# CONTEMPLATED CHANGE ORDER

PROJ.: Meridian Community  
Building Rebuild  
PROJ. No.: 1841  
DATE: Aug. 28, 2019  
C.C.O. No. 015

Terrace Planting

PROJECT NAME: The Meridian  
CONTRACTOR: D&G Landscaping Inc.  
PROJECT #: 2005-01

Drawing:  
**LANDSCAPE PLAN OPTION 01 (as existing)**

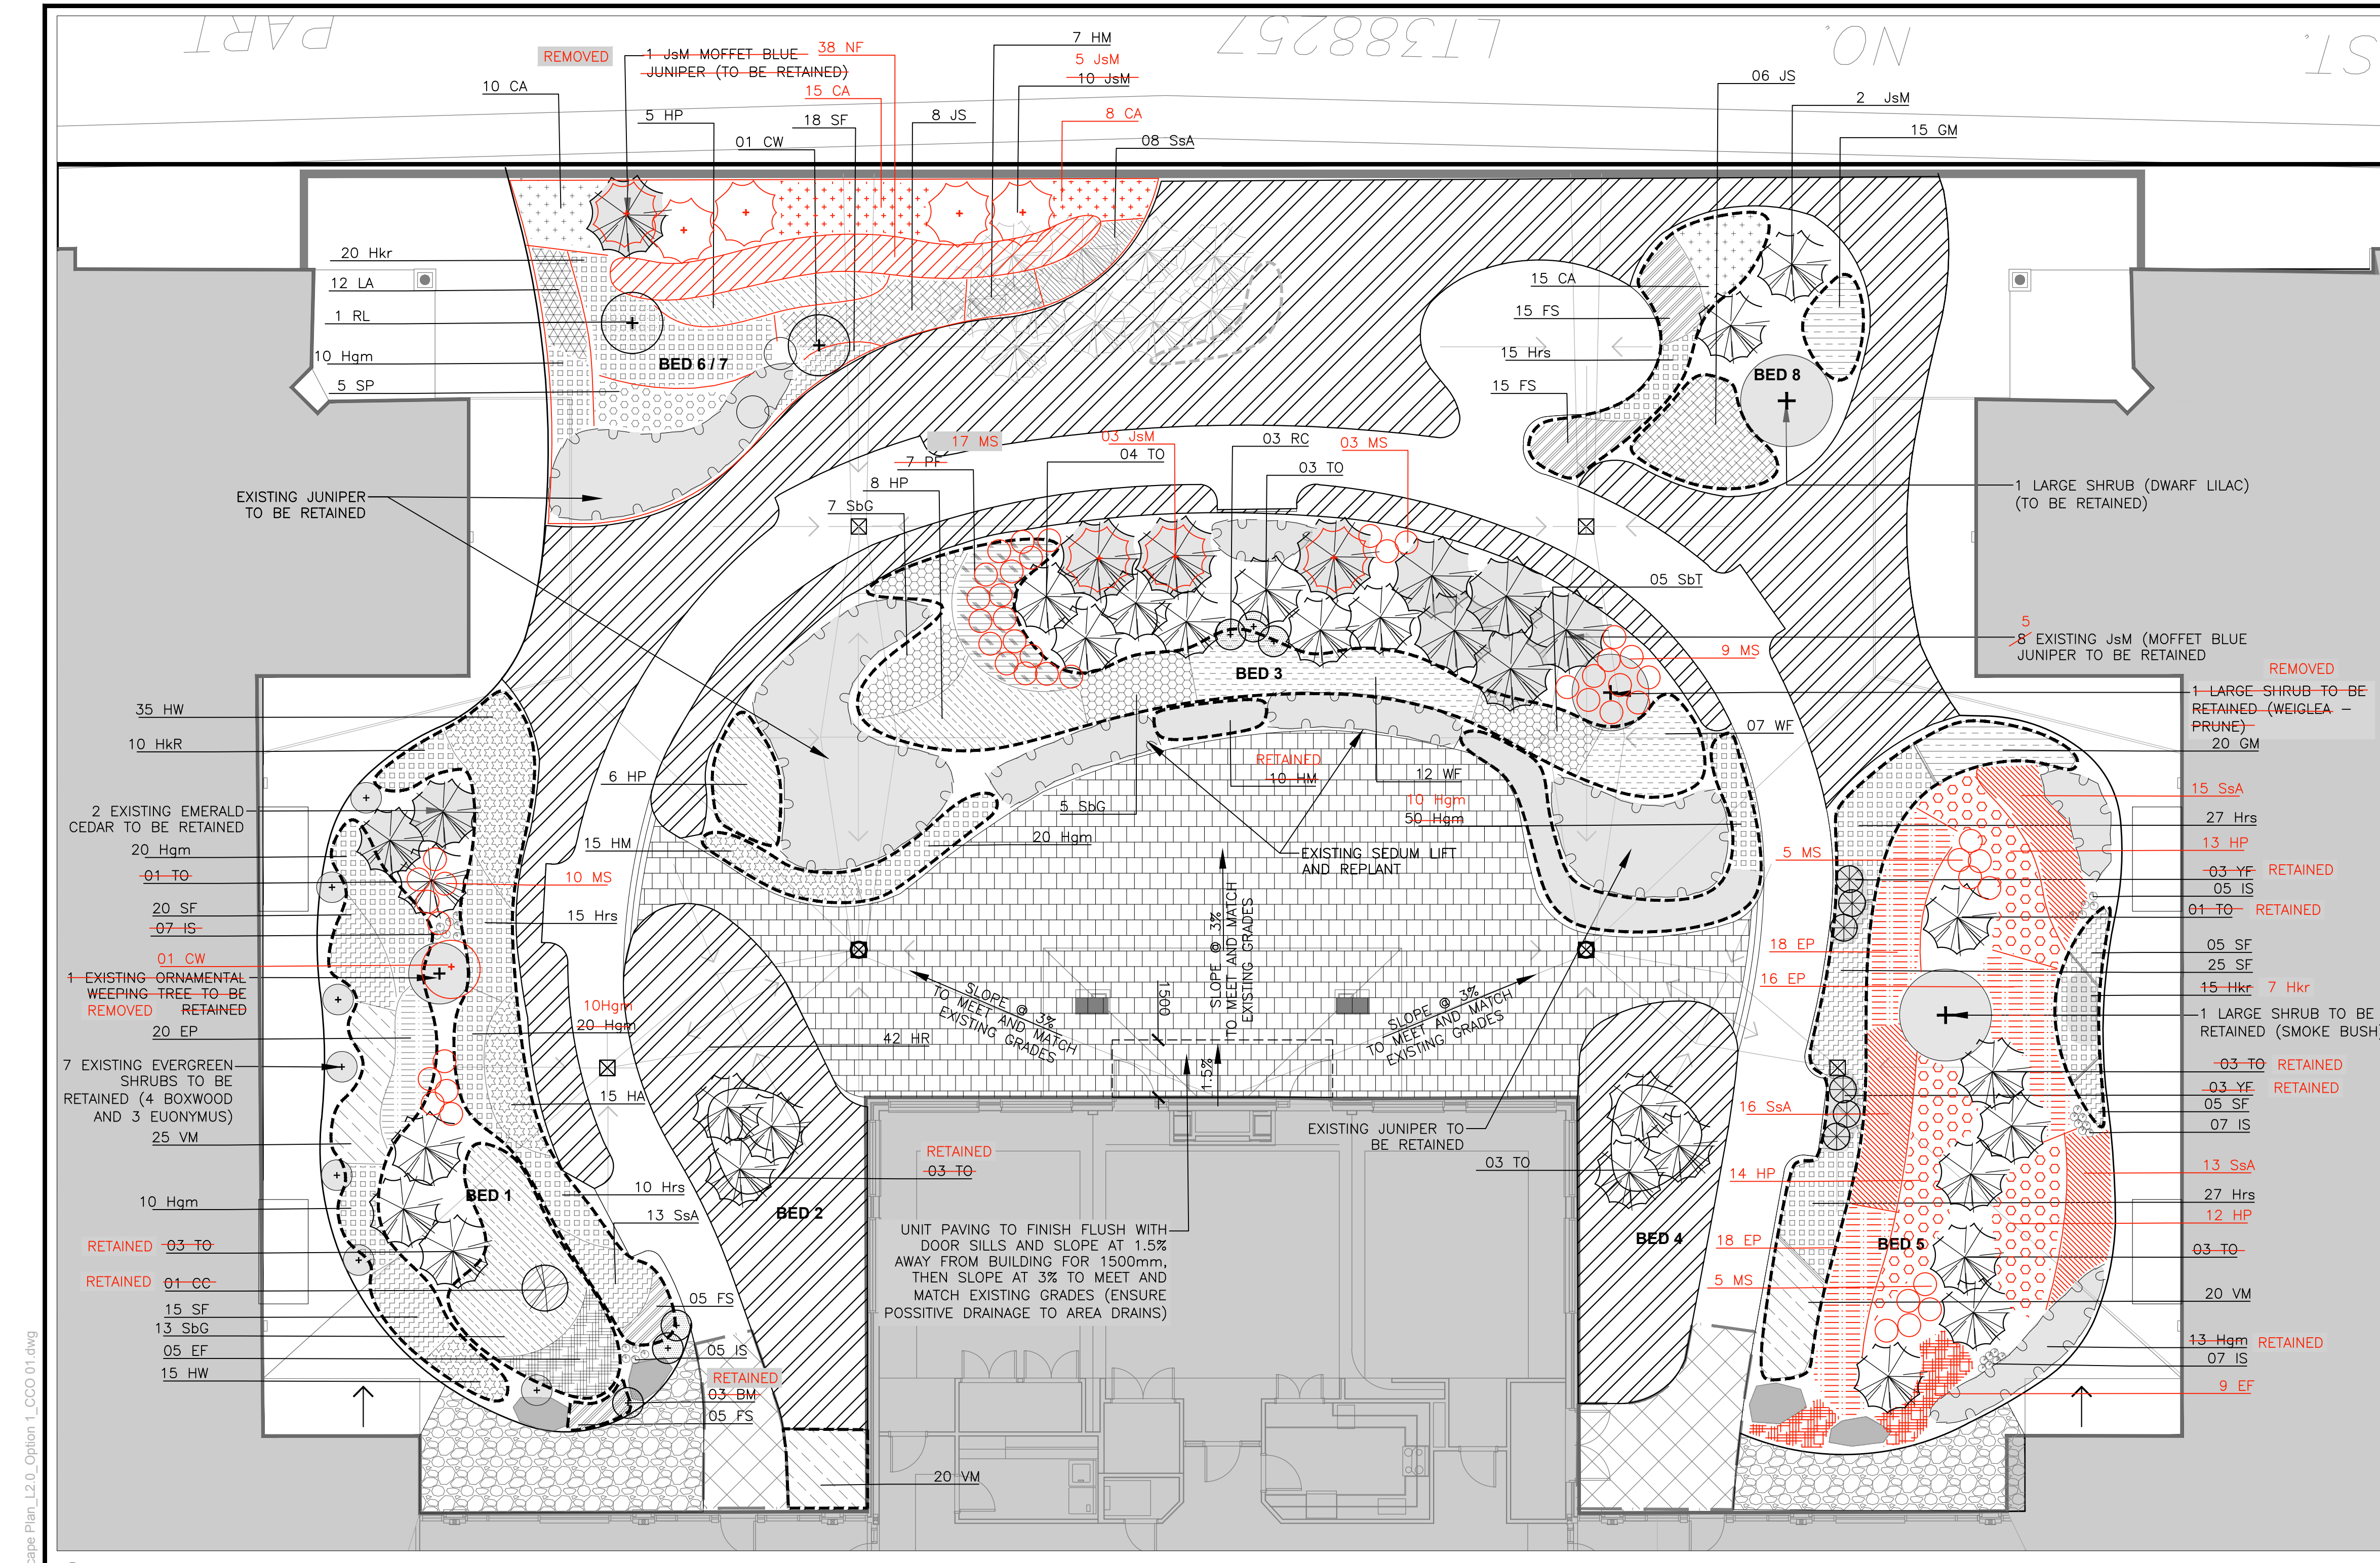
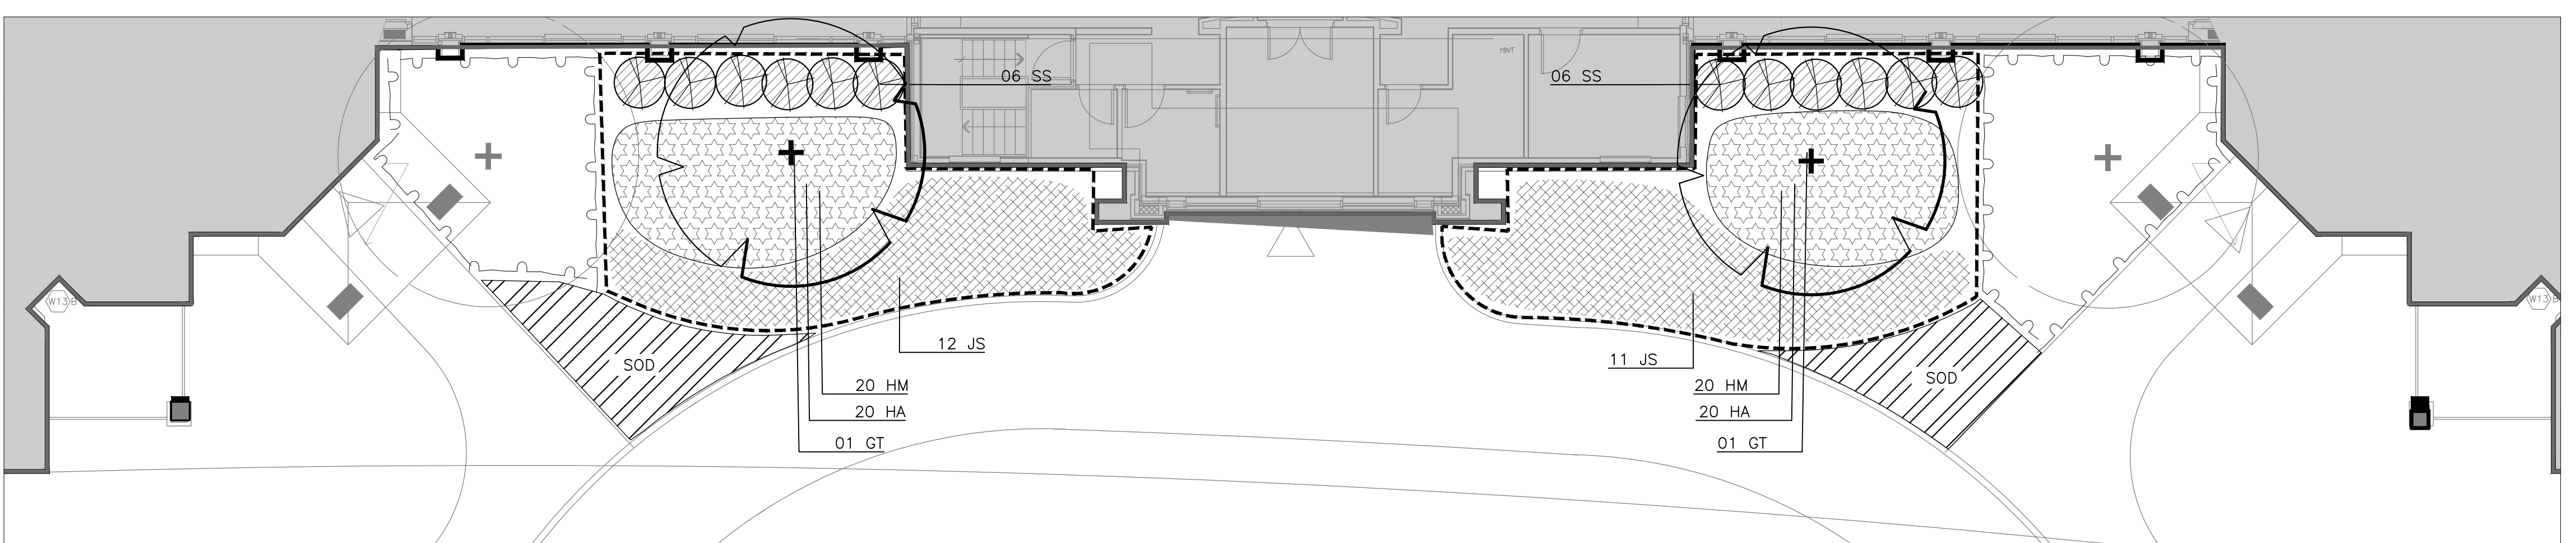
ITEM	DESCRIPTION	PRICE
1.0	<b>General:</b> As per Landscape Field Review 01 - Site conditions were found to have changed since the site was first reviewed in October / November 2018. Drawing L2.0 issue 03 has been revised to reflect the different plant material that was able to be retained and additional material that was required to be removed. An updated plant schedule is included for review/ pricing.

1.1	<b>Terrace Planting:</b> Review and provide quotation for changes identified on attached drawing L2.0 issue 03 which includes changes to existing planting that has been retained / removed and provides an updated planting schedule to suit revised site conditions. (Note: Beds 6 and 7 have been combined to form one planting bed, however the overall sq.m. of planting area remains the same. For Bed 5, an additional 90 sq.m. of bed preparation and new planting is required).

1.2	<b>Terrace Paving:</b> Lift and relay 155 m <sup>2</sup> existing unit paving to remove excessive weed growth and ensure even pathway surface with secure edging to planting beds. (Provide additional bedding sand/crushed stone as required).
